PENROSE LIBRARY FENCE – FBZ WARRANT APPLICATION

Downtown Review Board - September 3, 2024

Staff Report by Case Planner: Johnny Malpica, AICP

File Number	Application Type	Decision Type
FBZN-24-0005	Form-Based Zone Warrant	Quasi-Judicial

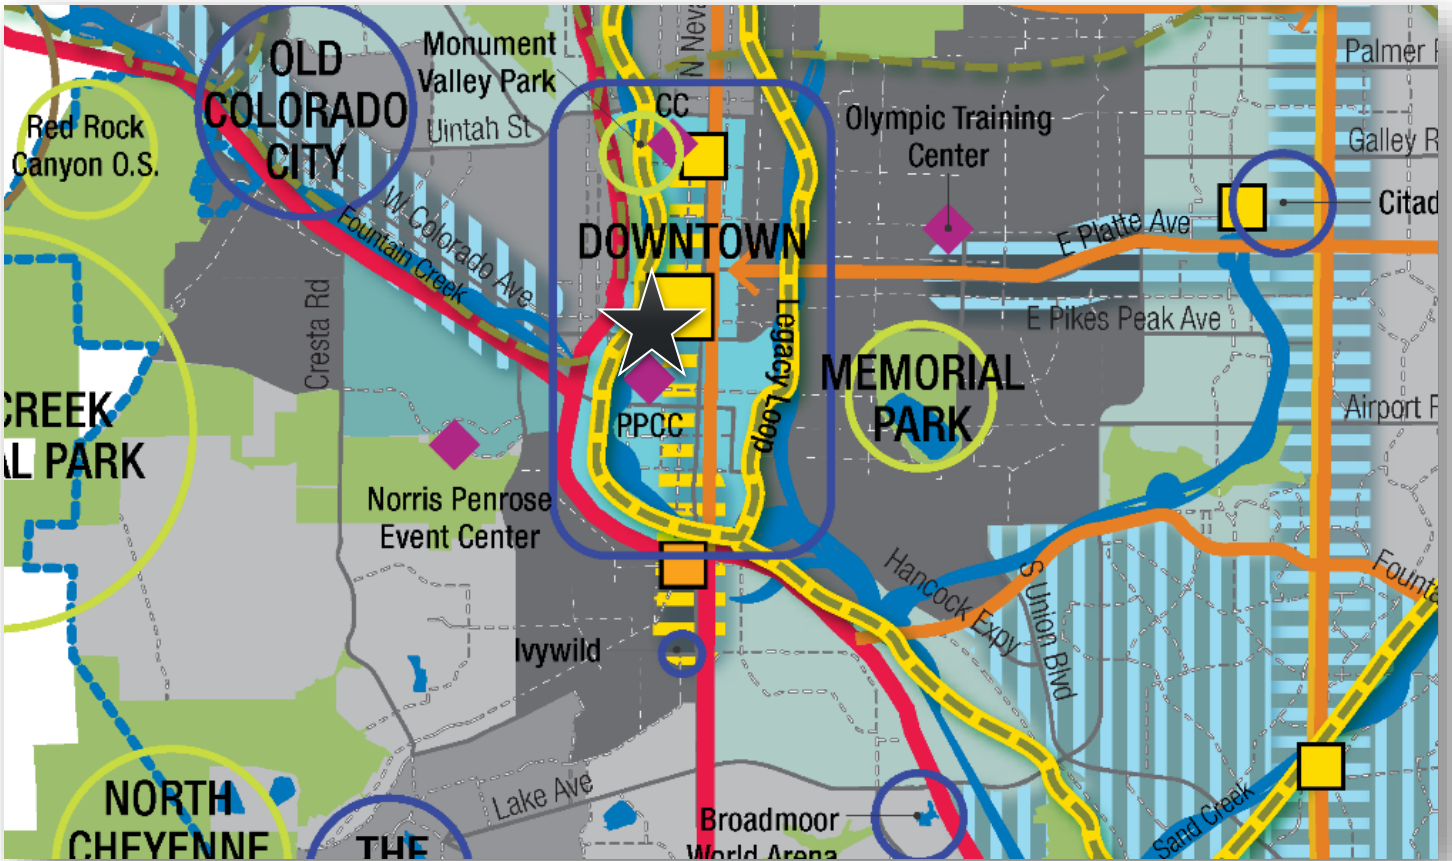
At the May DRB meeting, the Downtown Review Board considered alternative solutions and modifications to the proposal ensuring safety and comfort without compromising visual contiguity and the relationship of the site with the public realm. Those considerations required that the applicant engage in further consultation with Planning Staff to modify the proposal to limit enclosing the plaza space along N. Cascade Ave., as well as modifications to the fencing along the property line adjacent to W. Kiowa St., both of which serve as important pedestrian-oriented spaces within the Downtown. Following dialogue with City Staff, the applicant resubmitted a proposal on August 14, 2024. The revised plans included multiple notable design changes that still maintained the initial proposal’s intention to fence in the entire campus. However, both staff and DRB’s primary concerns were related to the enclosure of the public plaza space along N. Cascade. While the revised proposal still propositions to enclose this significant gateway area, it includes significant design enhancements that allow the space to feel more open, inviting, and visually contiguous with the surrounding landscape (See Figure 3). It should be noted that the revised proposal includes an increase in fence height from 7’ to 8’, however the increase in height is related to the new proposed fencing material so as to maintain sufficient security measures.

With consideration given to the above review criteria, the cultural significance of the Penrose Library, and its location and relationship to the pedestrian environment that surrounds it, Staff had initially concluded that the review criteria had not been met and suggested the proposal be modified to better meet the Common Lawn frontage standard and the criteria above. Considering the revisions made (See Figure 4 & 5), staff finds the proposal to be more aligned with the review criteria but suggests that the fence height be returned to 7’ throughout the perimeter, as was initially submitted. Furthermore, and specifically referencing the rearticulation of the enclosure of the plaza space, staff would suggest that the double wire fence be returned to 7’ in height, to ensure unobstructed visual contiguity. Along W. Kiowa St, staff suggests that the newly proposed double wire fence material be returned to the wrought iron style fence material that is 7’ in height, as initially submitted, and stepped back from the property line where possible. Finally, staff suggests that the plan and project statement be updated to include landscaping between the fence and the pedestrian way along portions of W. Kiowa St. to offset the imposing 7’ fence’s relationship to the pedestrian walkway.

Planning	<ul style="list-style-type: none"> - Reduce the fence height from 8' to 7'. - Step the fence back from the property line, where suitable to allow space for landscaping between the fence and the pedestrian ROW along W. Kiowa St. - Add landscaping along W. Kiowa St. Consider plant selections that have environmental benefit. - Replace the newly proposed 'Secur' (double wire fence) along W. Kiowa St, with the wrought iron style fence that is 7' in height, proposed in the initial submittal.
Fire	<ul style="list-style-type: none"> - Minor technical modifications. - Removal of two parking spaces to ensure adequate turnaround for fire apparatus vehicles. - Submittal of a separate permit through the Colorado Springs fire department, to be reviewed concurrently with this plan.
Enumerations	<ul style="list-style-type: none"> - Clarification regarding fencing height, that if 7' or over may require addressing.
